REMARKS

VERSION WITH MARKINGS TO SHOW CHANGES MADE

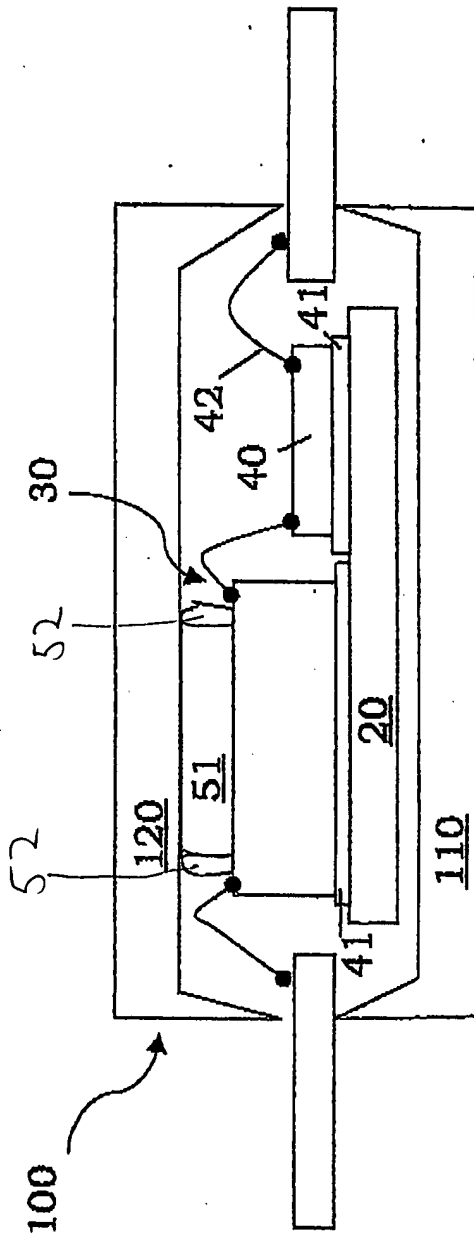
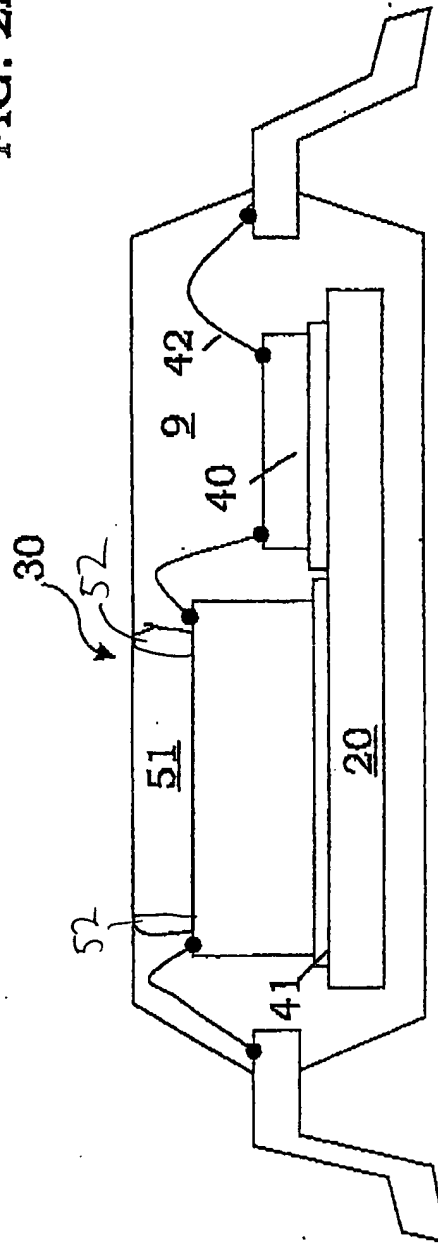
The drawings were objected to as failing to show the “dyke or barrier” of claims 22-23. Being filed herewith is a request for drawing change showing a dyke or barrier 52 in Figures 2A, 2B in accordance with claim 22 and the original specification. Claim 23 is being canceled.

Advantageously, a ring 52 is provided on the cap of the sensor 30, which is formed out of semiconductor material, for example. This ring (~~not shown~~)52 is filled with the covering layer 50 material. Thus, the ring 52 will form a barrier or containing dyke for the covering layer 50.
